PROJECT NAME
Alpine Street Garage

PROJECT ADDRESS
11-15 ALPINE STREET
SOMERVILLE, MA

REVISION TO ZBA 2016-75
September 16, 2021

List of Changes; Refer to Accompanying Narrative.

A-103

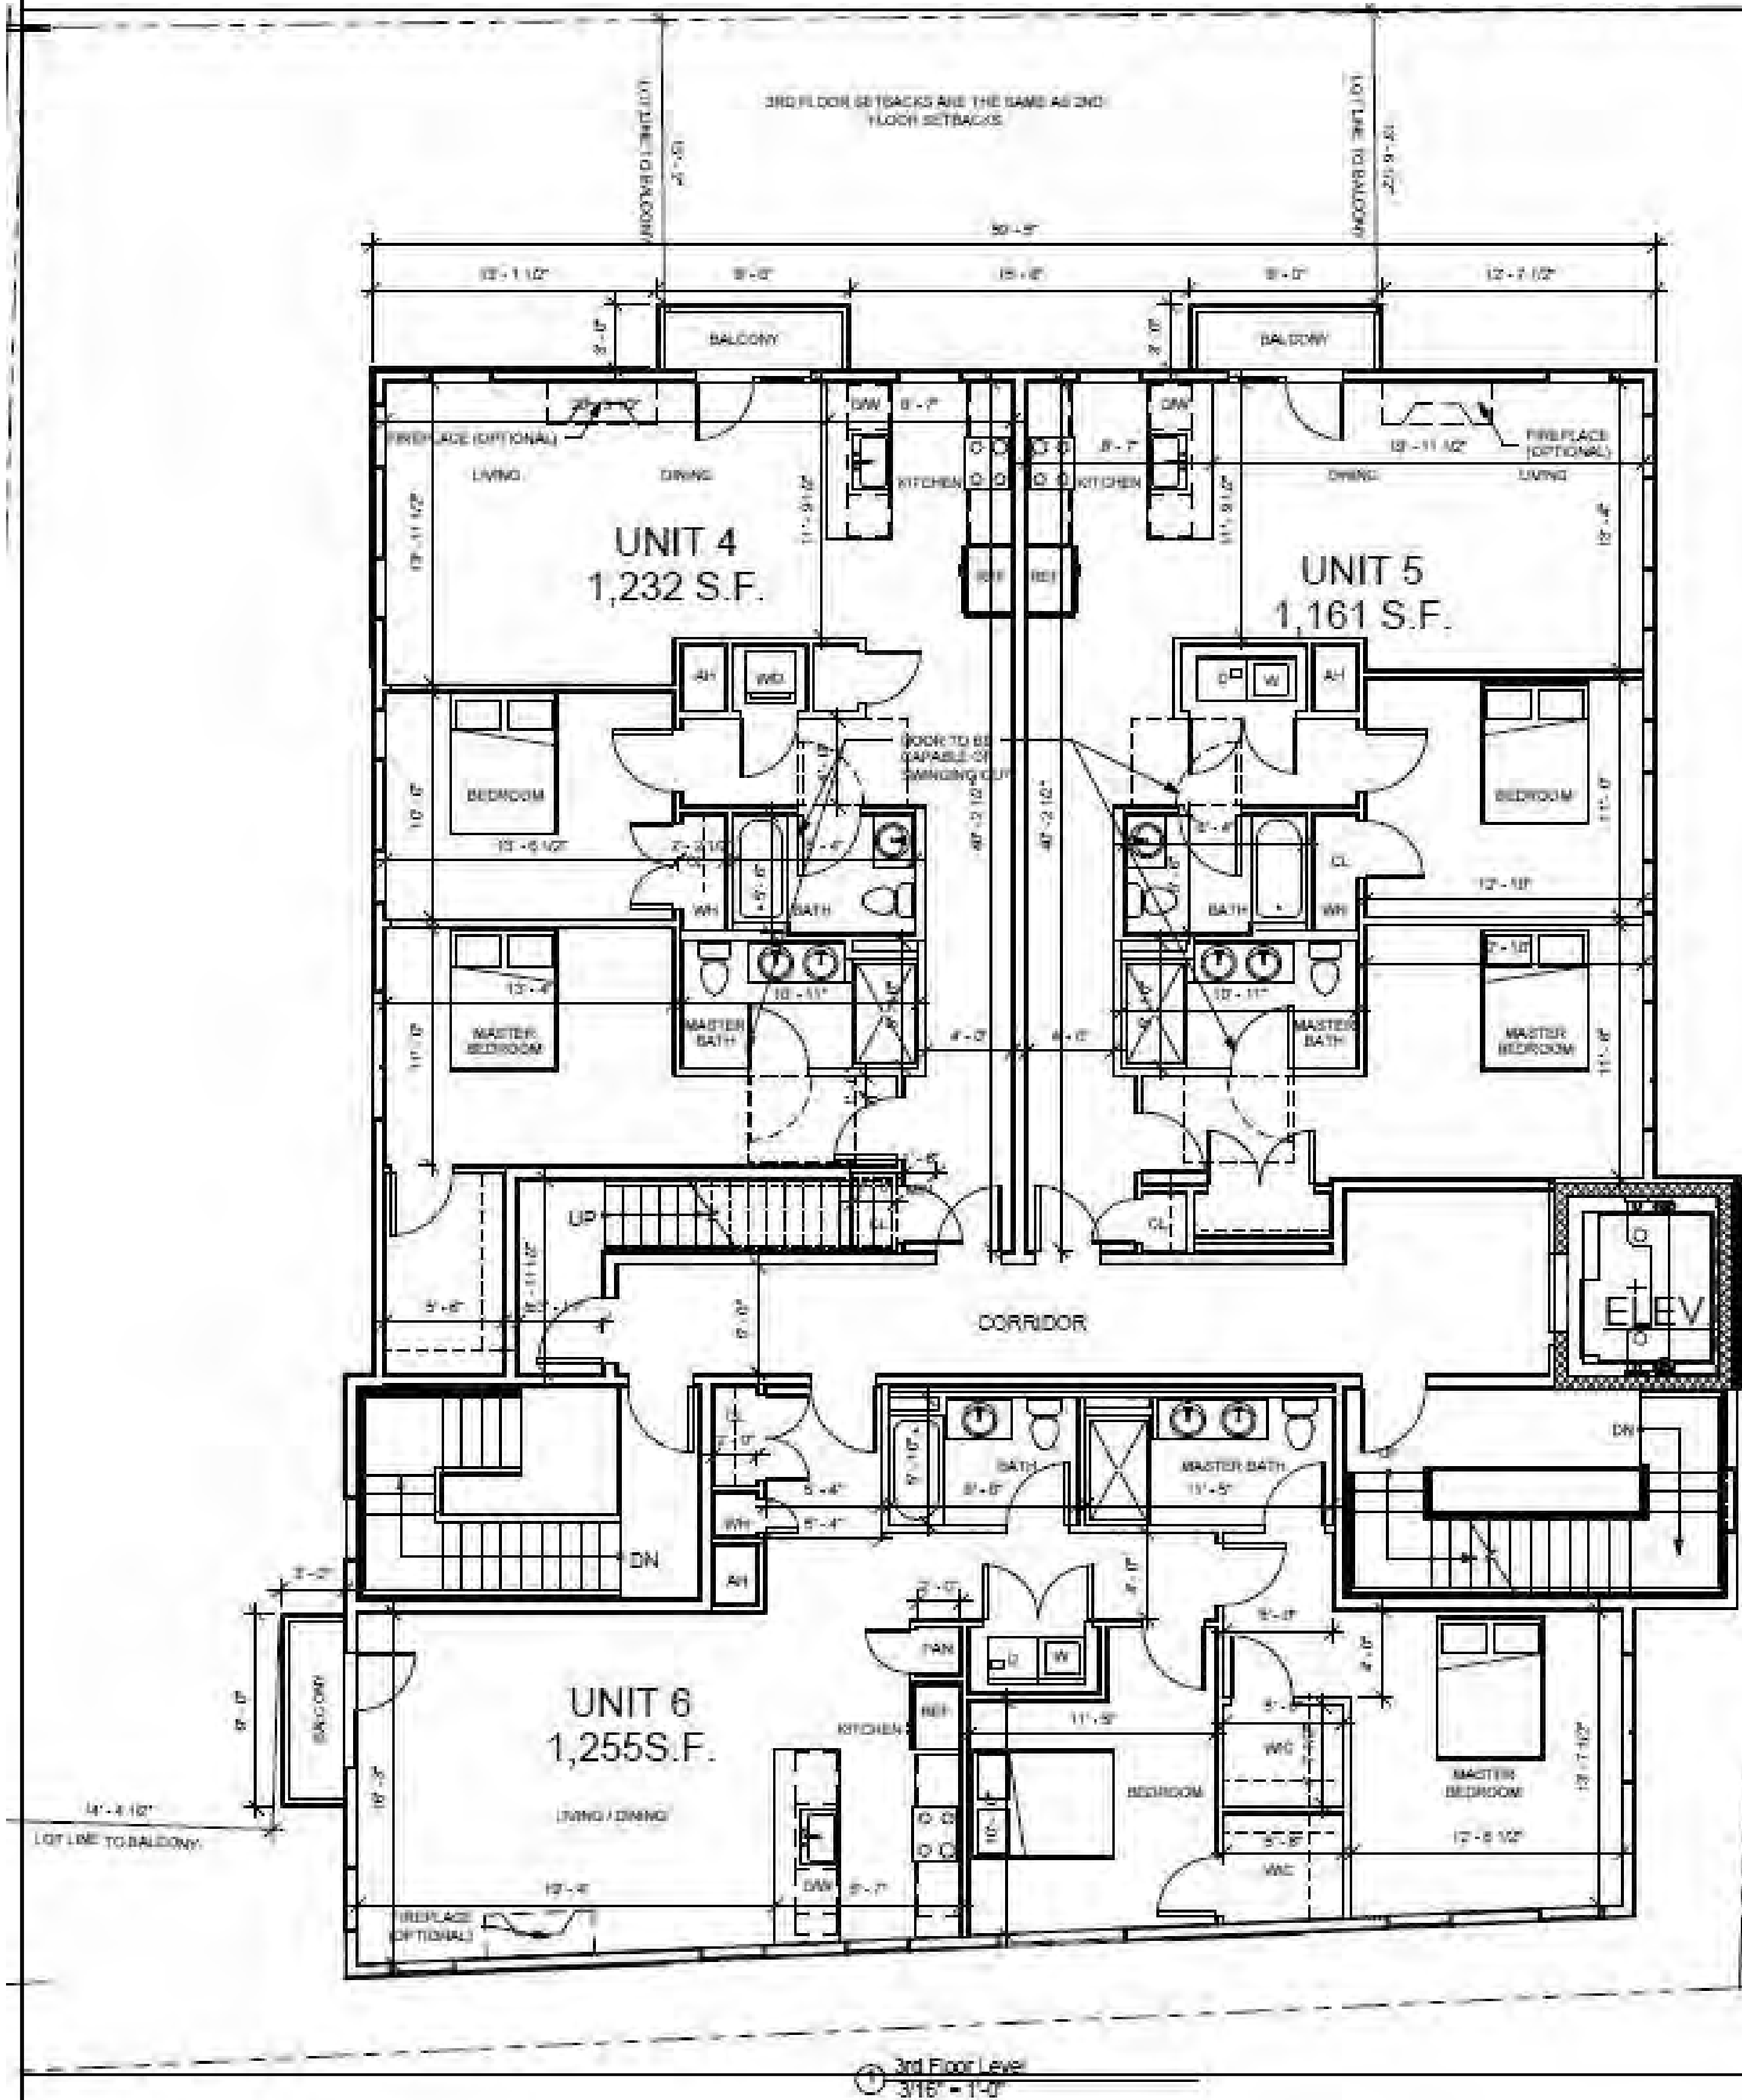
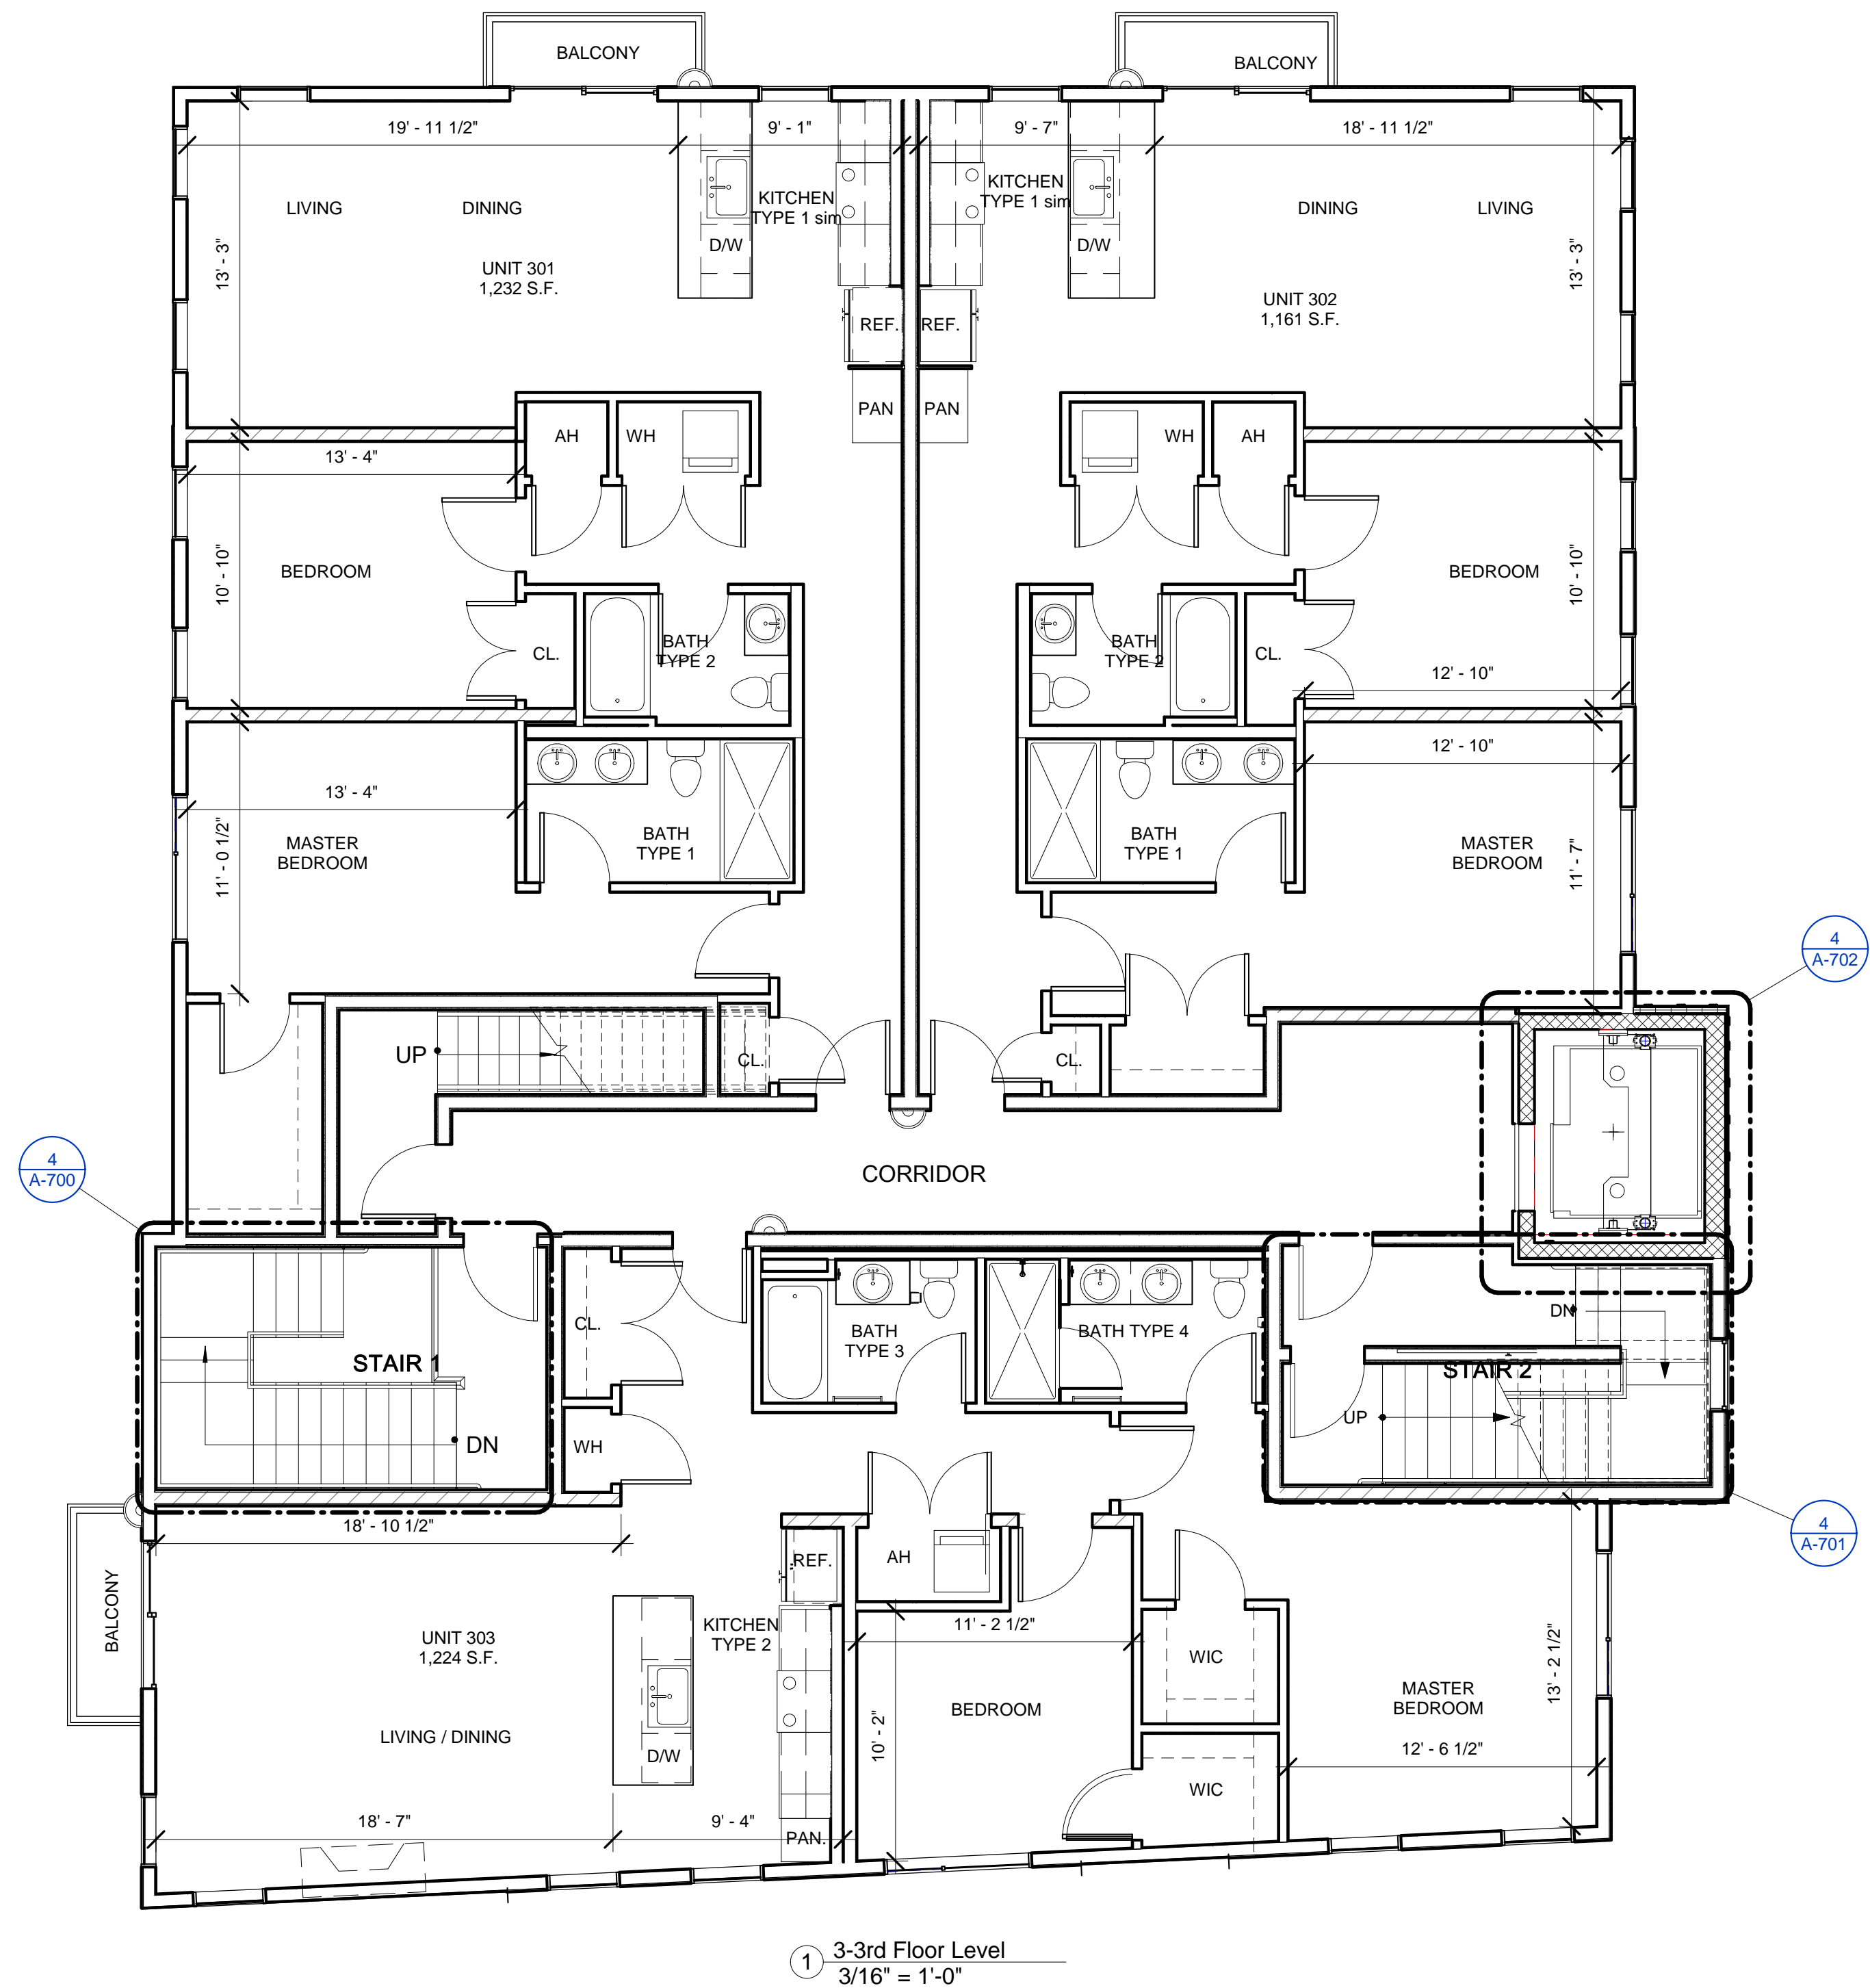
1. The right-side elevation staircase overrun on the roof, which is adjacent to the rooftop elevator overrun, has been extended to match the height of said adjacent elevator overrun.
2. The batten pattern at the top floor and right-side stair tower has been adjusted.
3. New cast stone signage at the center of the front façade is now proposed to read "13 Alpine Street".
4. The veneer at the front wall headers and columns is to be changed to cast stone (Arriscraft or Similar).
5. CMU block is to be used on the Easterly wall.
6. The door and window pattern at the front left side ground floor space has been altered as shown in the elevations.
7. The windows have been slightly altered on all facades as shown in the elevations.
8. The front wall has been replaced as shown in the elevations.
9. The iron railings are to be horizontal.
